City of Newburgh Council Work Session
*Sesion de trabajo del Concejal de la
Ciudad de Newburgh*

June 6, 2024
6:00 PM

5. Change Order No. 5G with Kubricky Construction on the LTCP (Phase-III) North Interceptor Sewer Improvements Project

Resolution authorizing Change Order No. 5G to the construction contract with Kubricky Construction Corp. increasing the contract amount by \$2,150,000.00 and increasing the total contract amount from \$28,751,184.80 to \$30,901,184.80 in the North Interceptor Sewer Main Improvements Project

Exhibit B – Cutter Inspection Form

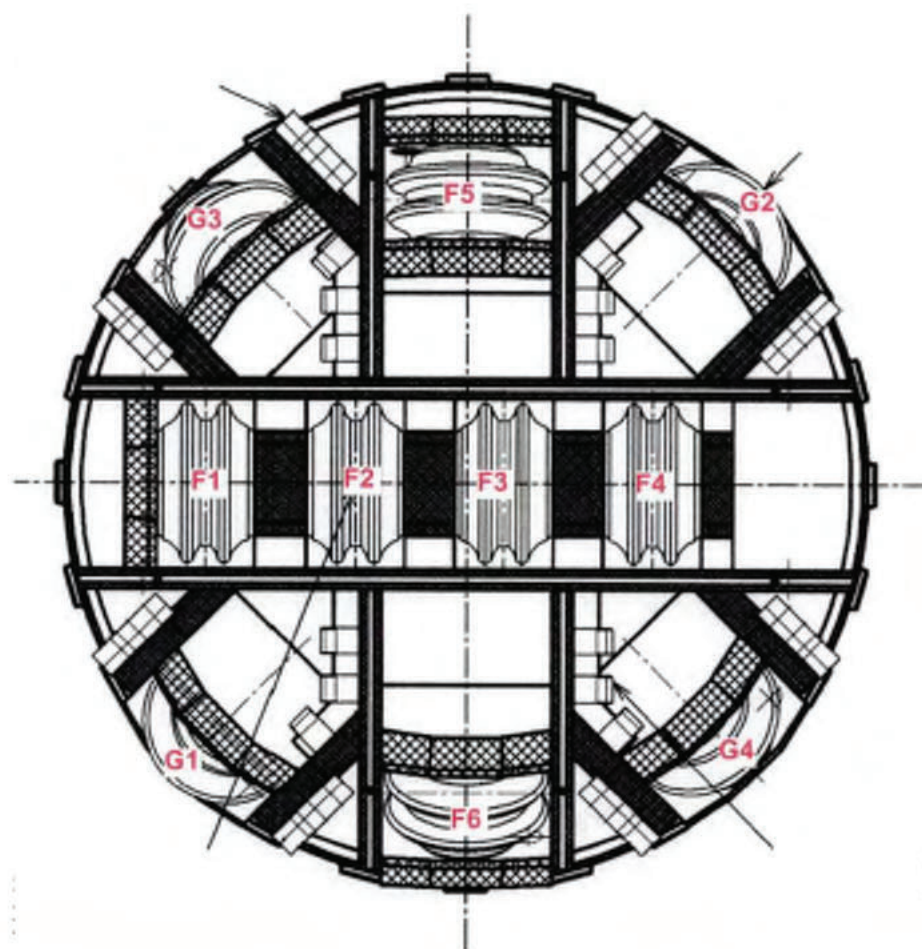
CUTTER INSPECTION REPORT

Tunnel Drive L 3Date: 2-25-23 Time: 11:50 - 2:30Station / Dist: ~ 293 LF

FIELD REPORT

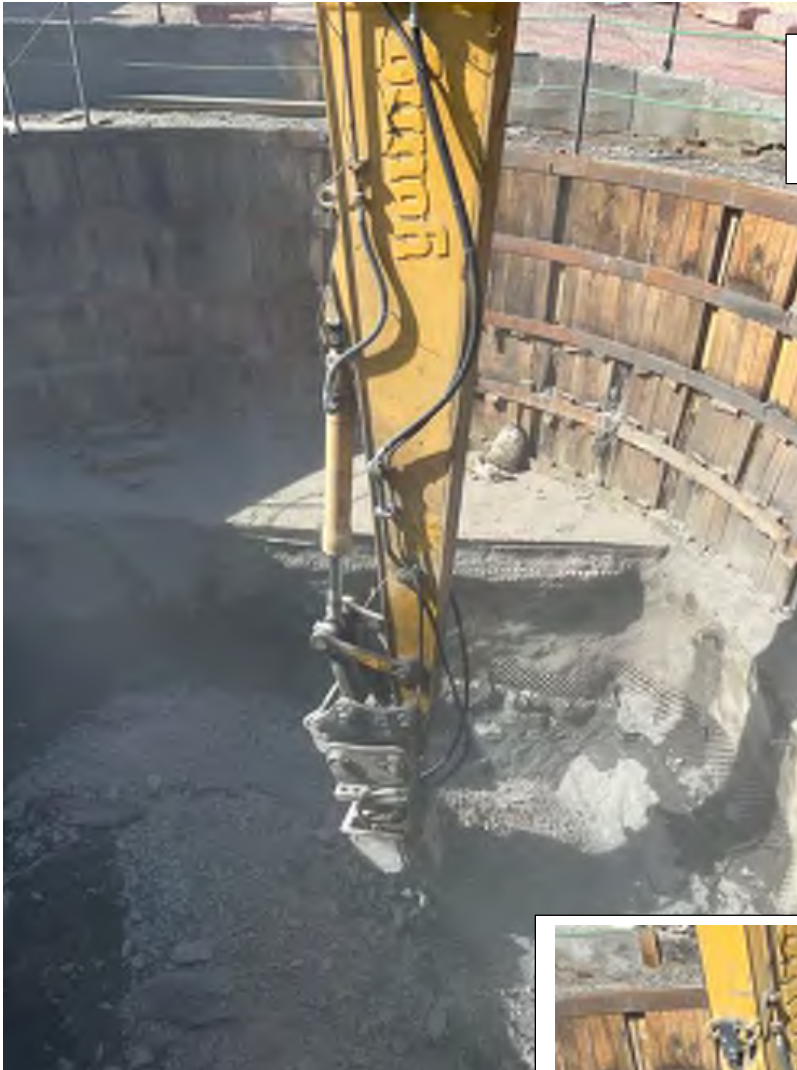
Photo 1 and 2 – Shaft 2138 during rock excavation.

Photo 4, 5 – Overview of hard rock within Shaft 173, note quartzite veins.
